SUBJECT: Forwards responses to 851025 request for addl info re SPDS.
 Review & issuance of SSER requested. Display design modified
 such that Class 1E multiplexer cards powered from Class 1E
 power within div.

SHEARON HARRIS NUCLEAR POWER PLANT
UNIT NO. 1 - DOCKET NO. 50-400
SAFETY PARAMETER DISPLAY SYSTEM

Carolina Power & Light Company submits responses to your staff's request for additional information identified in the NRC's Safety Evaluation Report (SER) for the Shearon Harris Nuclear Power Plant Safety Parameter Display System (Reference 1). Please review these attached responses and issue a supplemental SER.

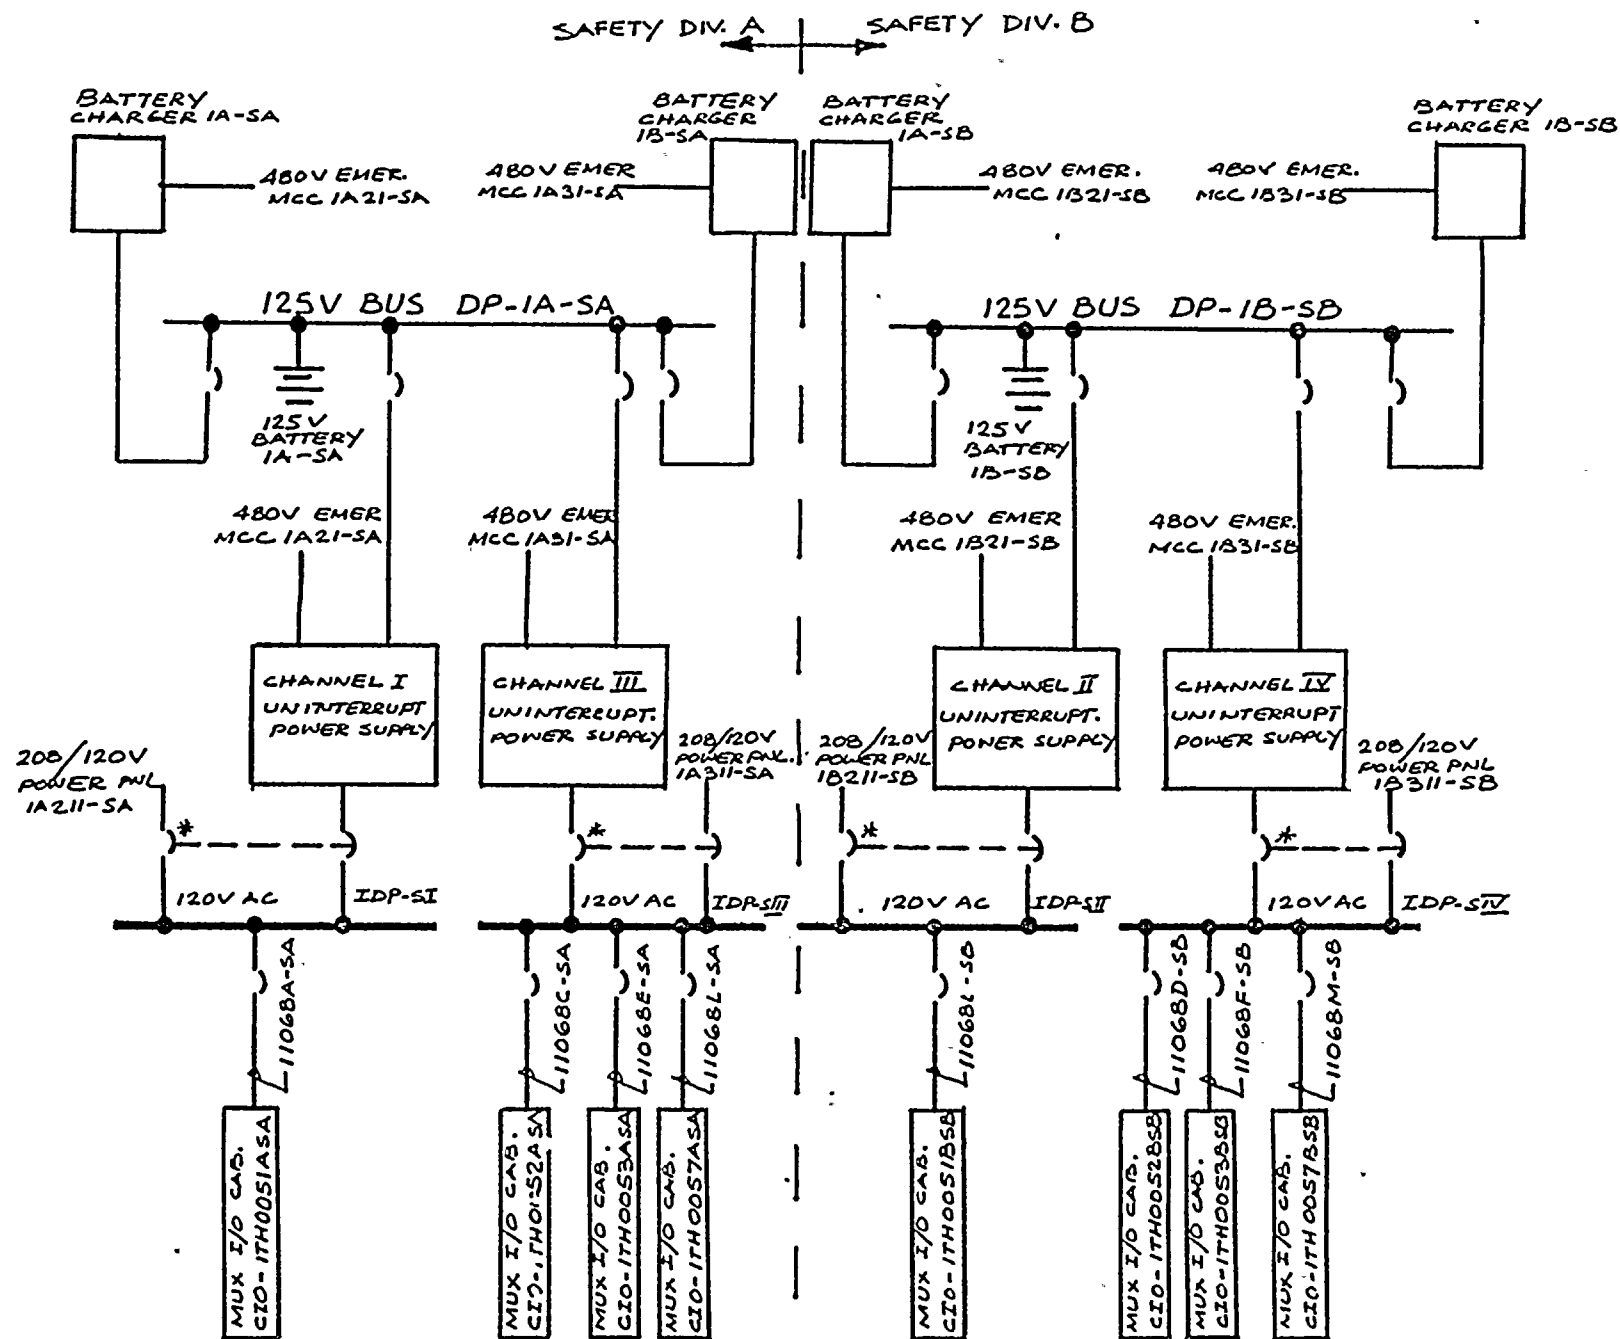
Modify the display's design such that the Class 1E multiplexer cards be powered from Class 1E power within their division. This modification shall be completed prior to declaring the safety systems operational for the plant. Documentation to support this modification should be submitted to the NRC for confirmatory review.

The display's design has been modified such that the Class 1E multiplexer cards are powered from Class 1E power within their division. Documentation to support this modification is attached. The modification will be completed prior to fuel load.

FIGURE 1-1
ERFIS/SPDS EFFORT

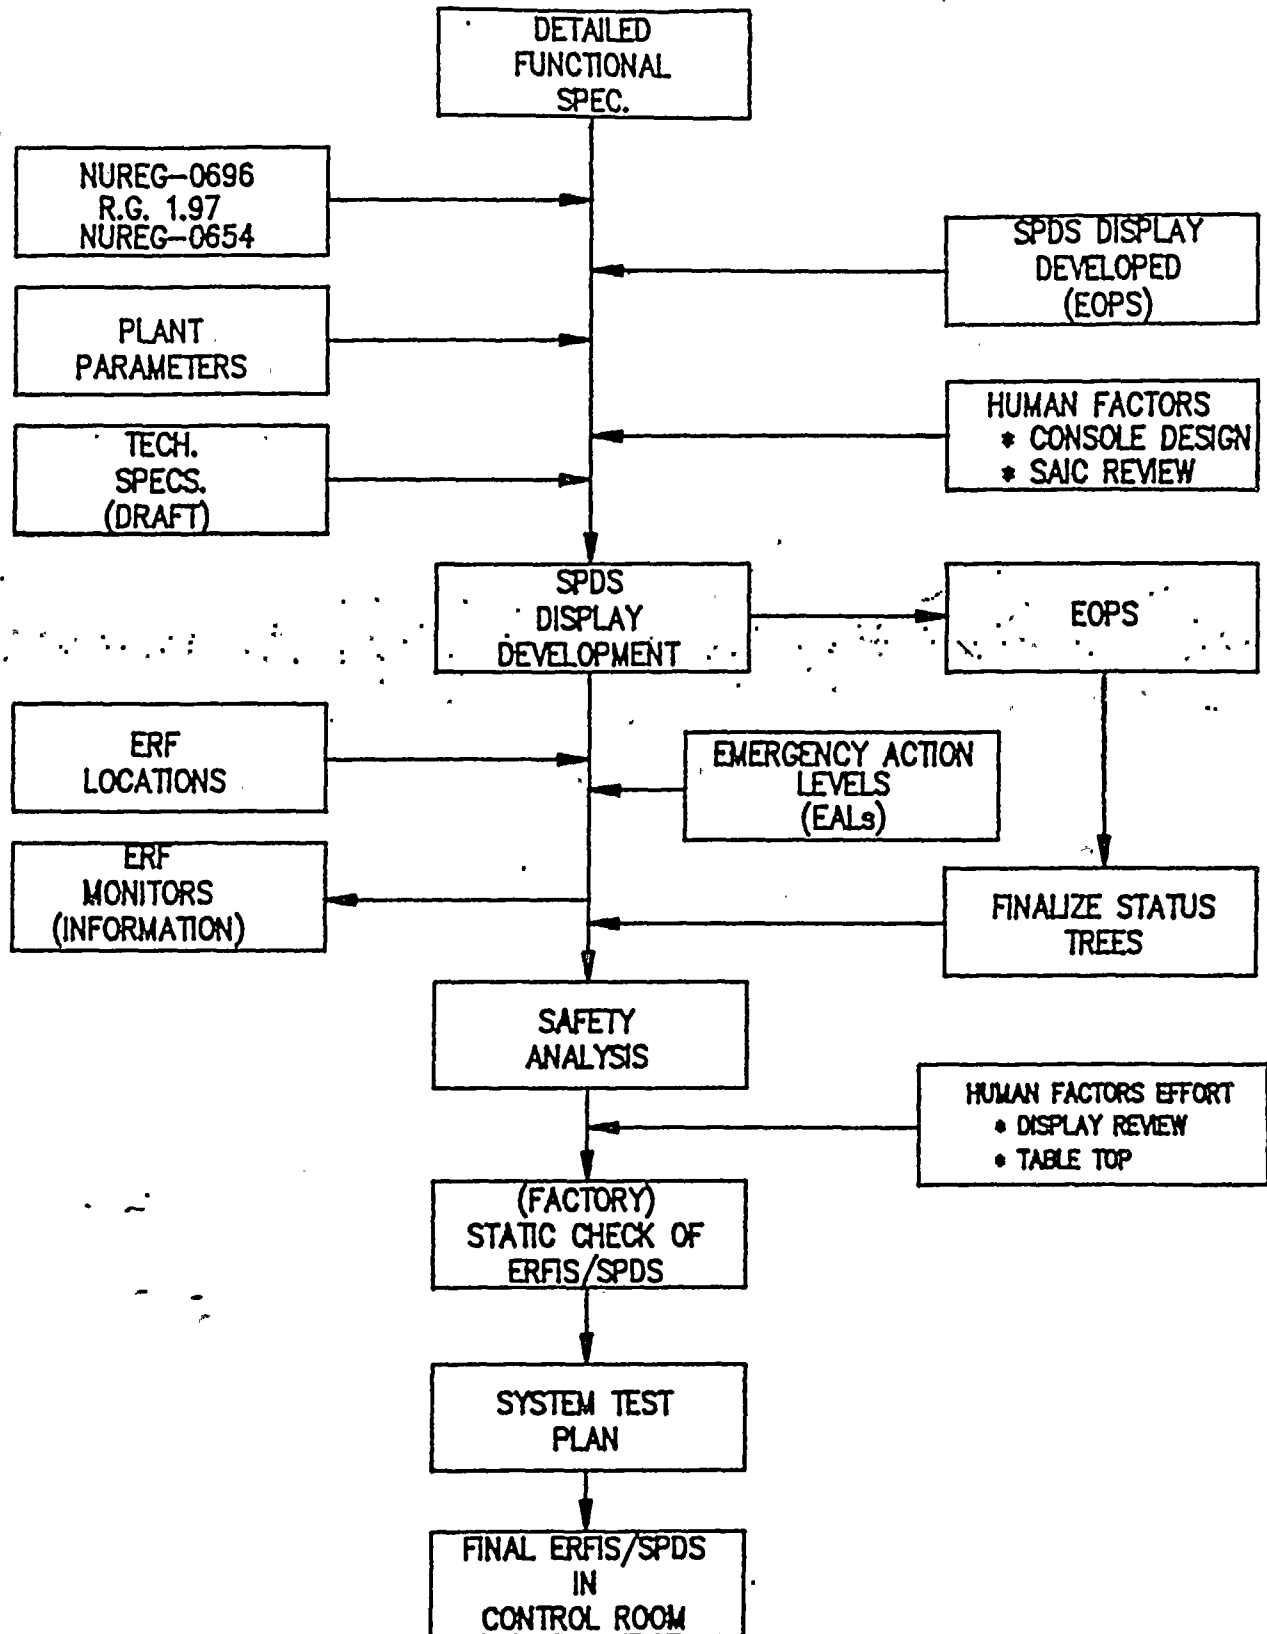
A Validation Test Report which describes test results and plans for resolution of problems identified during the test program.

CP&L has a high degree of confidence that the Final Validation Test Report will demonstrate that the SHNPP SPDS is an extremely well designed computer system. The SPDS has been developed from the top down as shown in the attached figure. Additionally, hardcopy outputs of the as-designed SPDS have been used on the Harris simulator with great success and acknowledged by the NRC staff in a Trip Report dated May 22, 1984. The Final Validation Test Report will be available prior to startup following the first refueling outage.
